ADDENDUM

PROJECT: Forestside Estates
Attmar & Palleschi Drive
Brampton, Ontario

PROJECT NO.: 18-017

ADDENDUM NO. E-4

TITLE
**4TH FLOOR PLAN
ELECTRICAL**

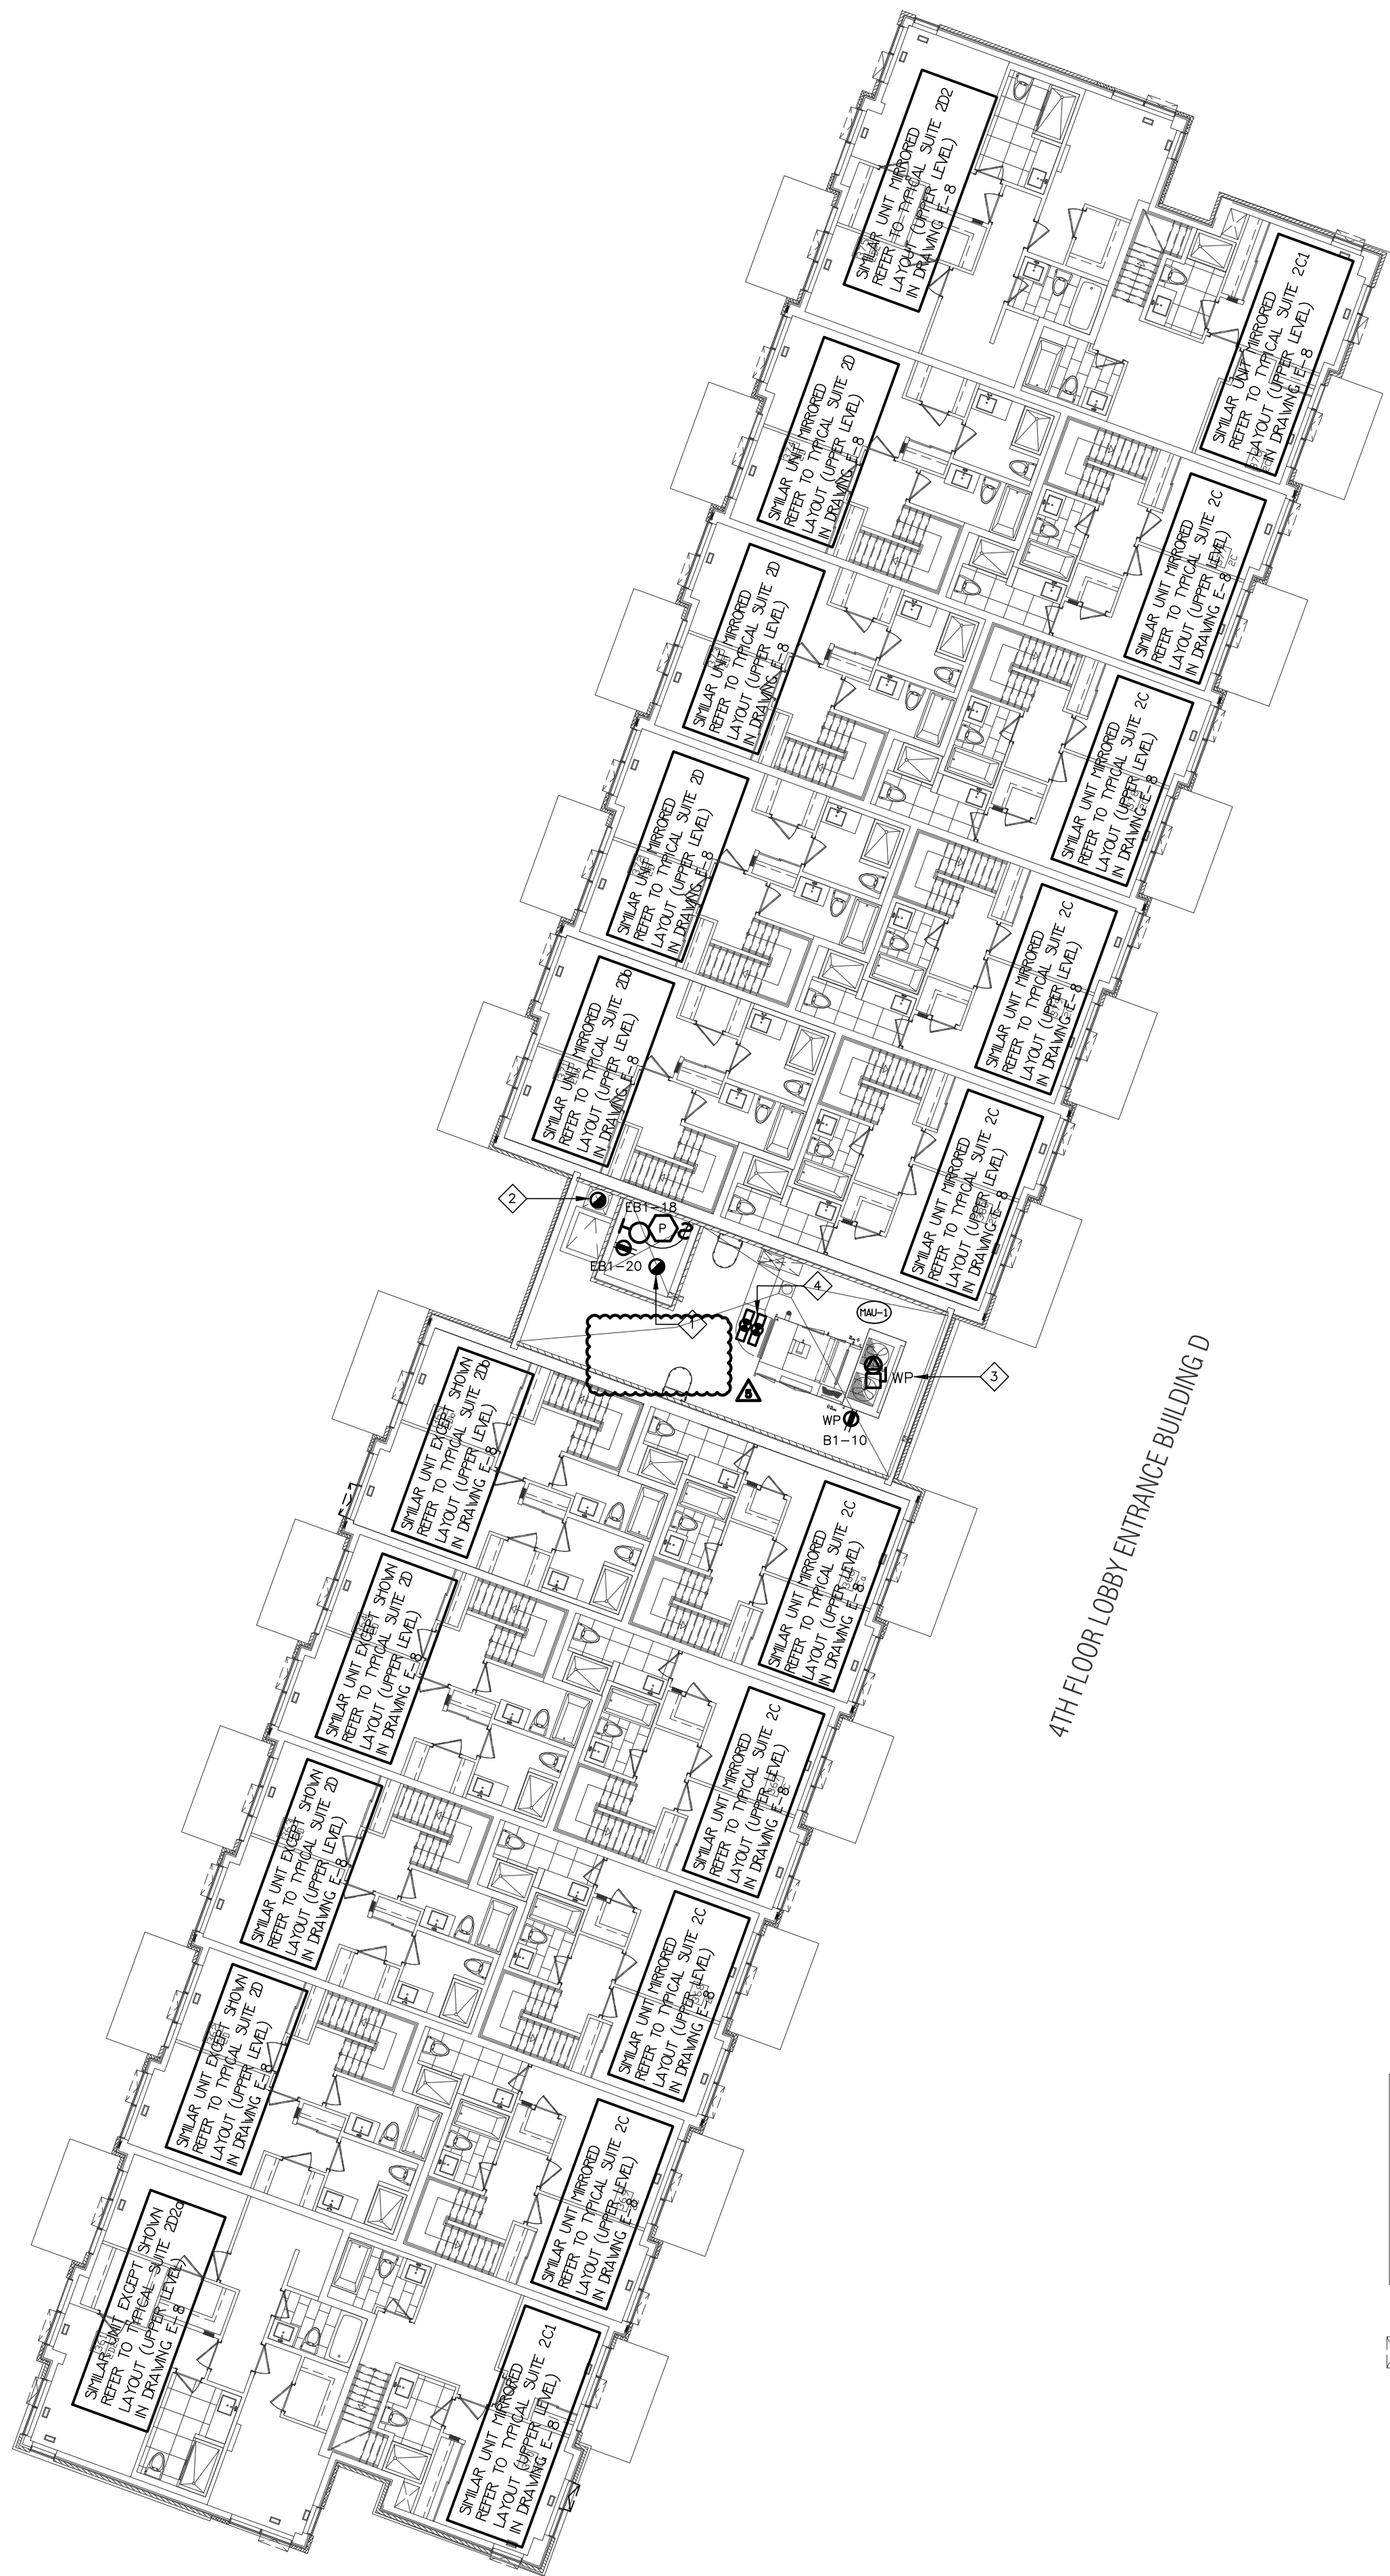
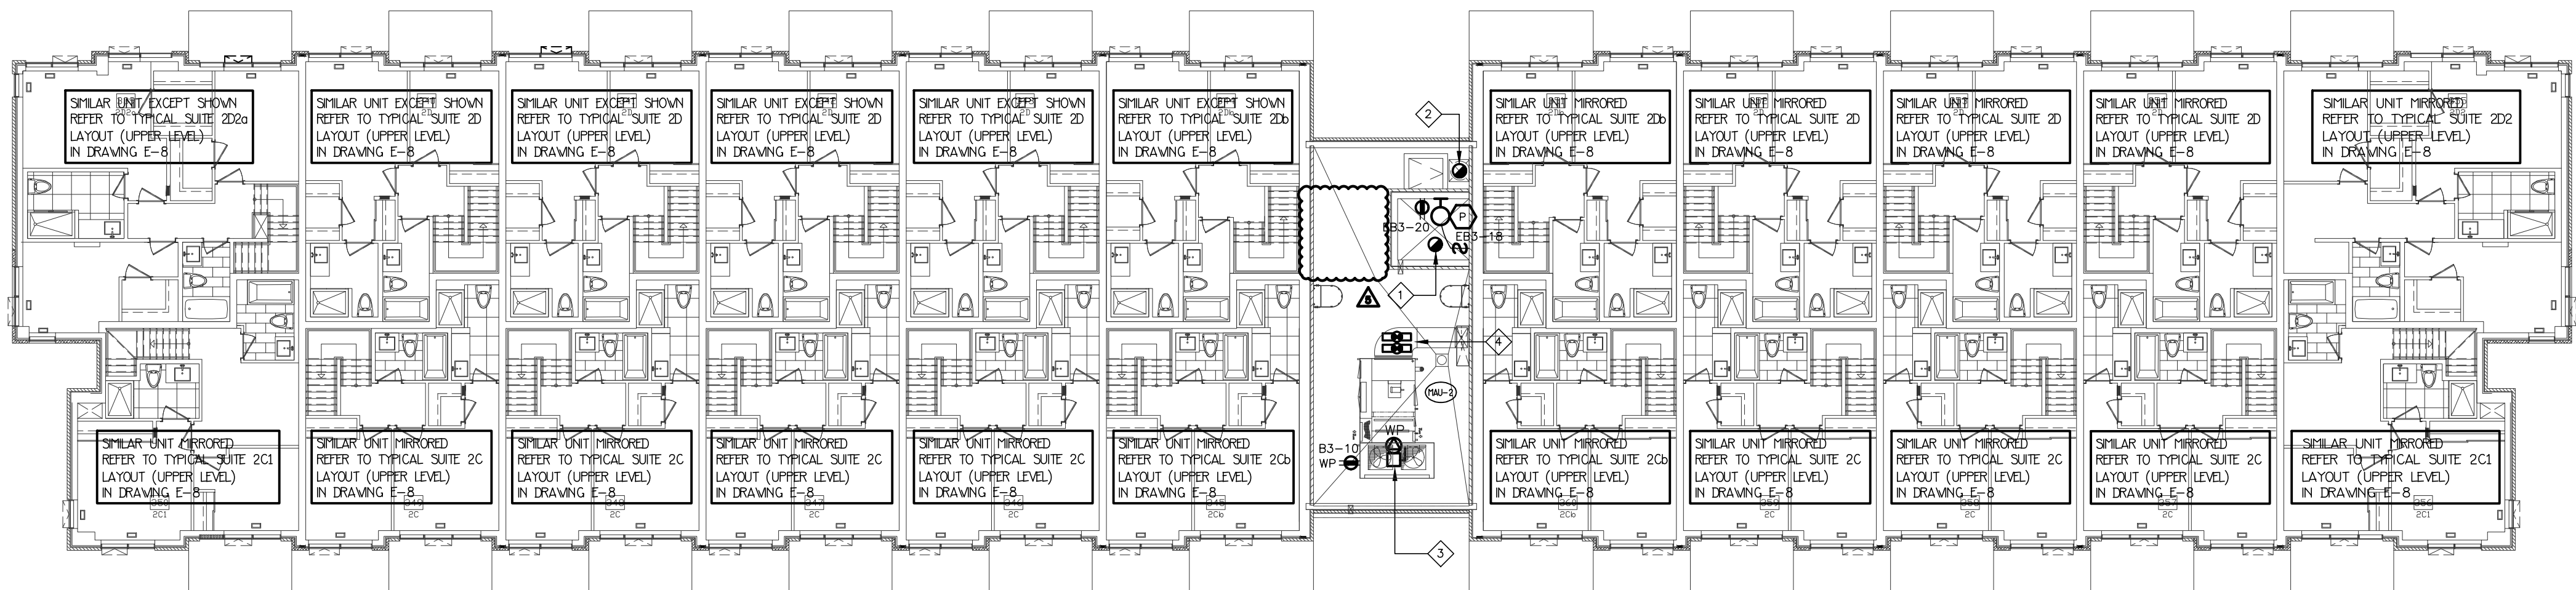
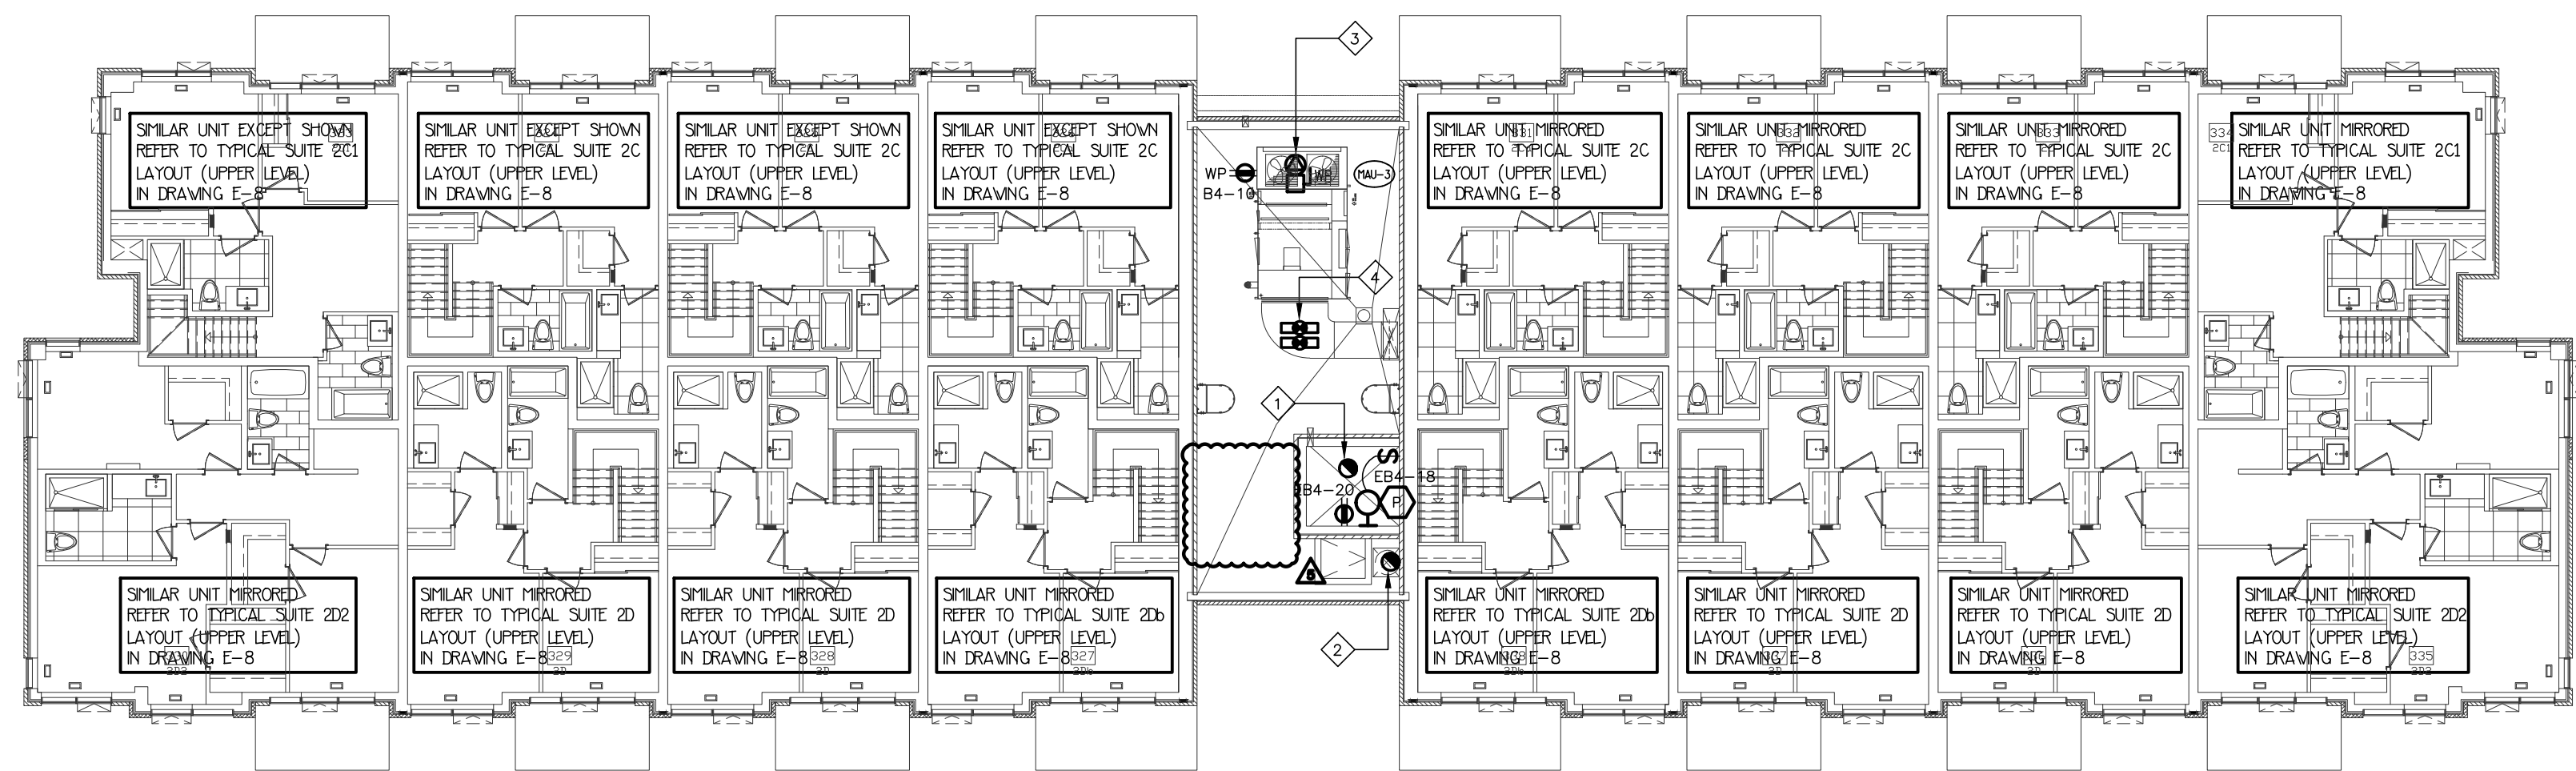
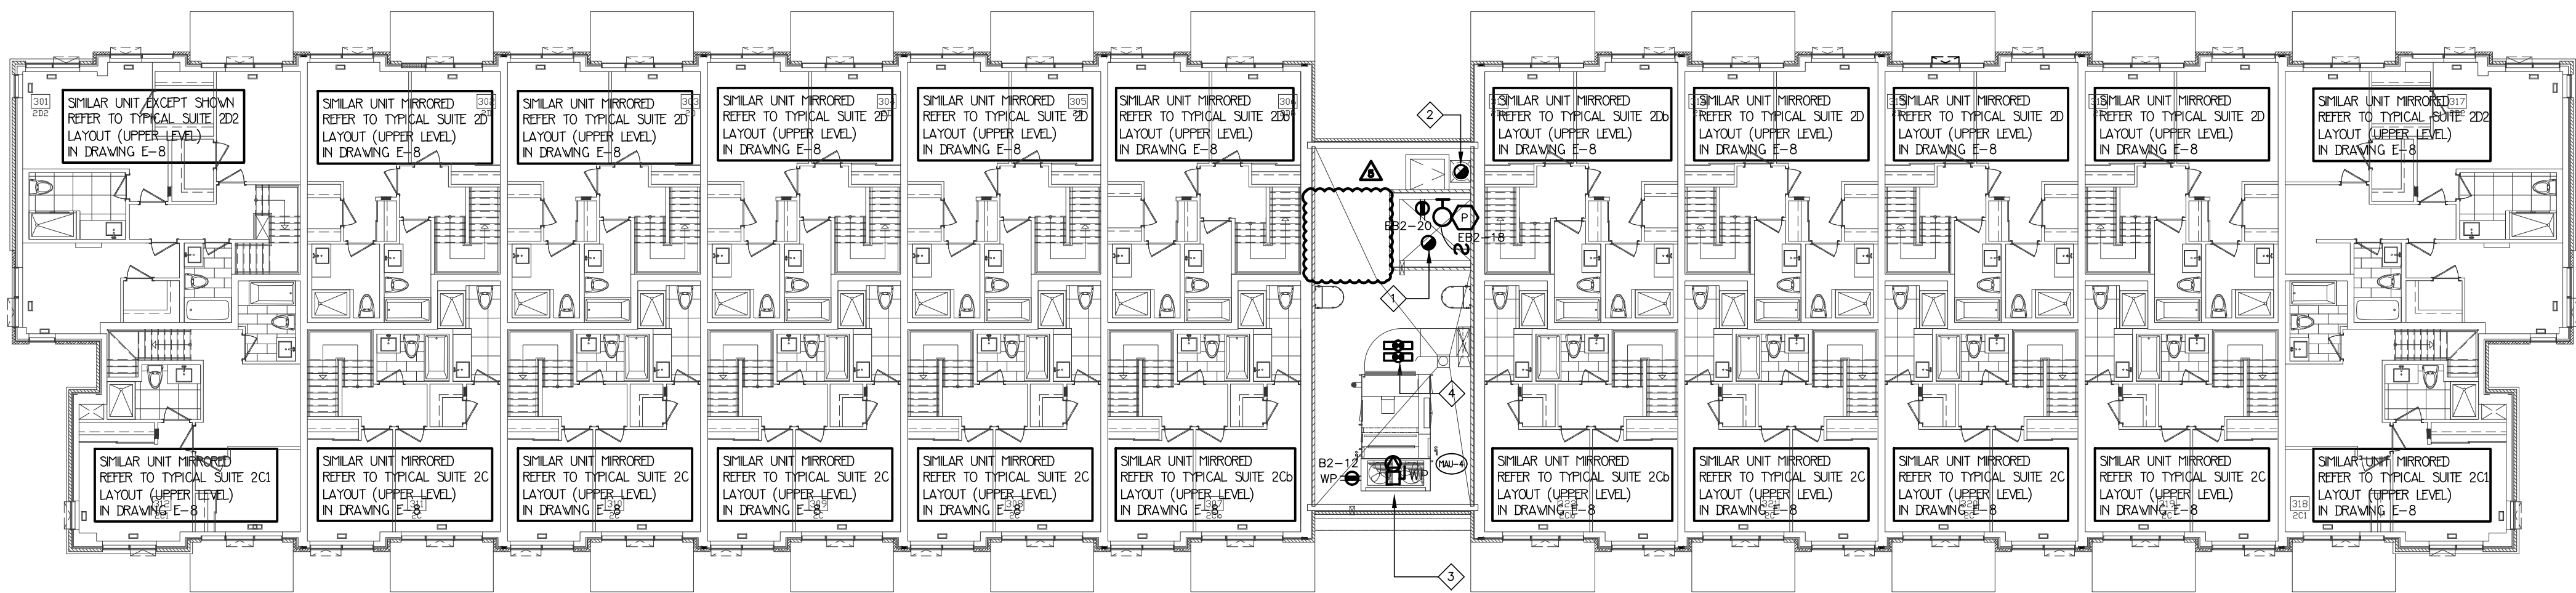
3.1 Revise: Floor plan background suit latest arch drawings as shown.

3.2 Delete: Split system blower & coil 'E-5' & condenser units 'E-6' for lobby area.
